# Service Bulletin

**TAT SB09-01**

Rev. B: 6/29/12

Model SR22 w/ Turbonormalizer

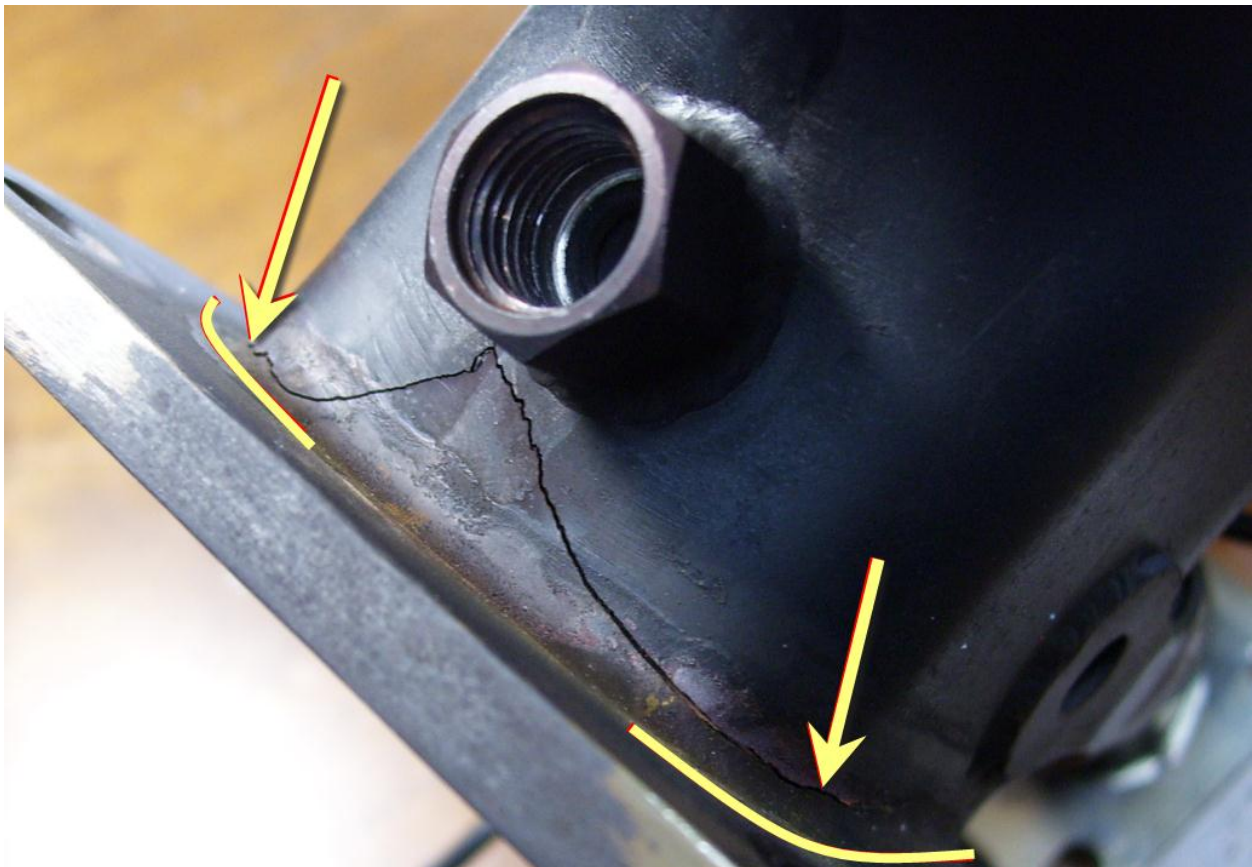
The purpose of this Service Bulletin is to instruct owners of Turbonormalized Cirrus Design SR22 Series airplanes to have the exhaust manifolds inspected for cracks around the turbo mount flanges. (See Picture)

- While cowling is removed, use a flashlight and inspection mirror to inspect the right and left exhaust manifolds for cracks around turbo mount flange.
- If cracks are found replace exhaust manifold in accordance with Instructions for Continued Airworthiness, Report 22-6460004.

Inspect corners and radii indicated by the arrows.
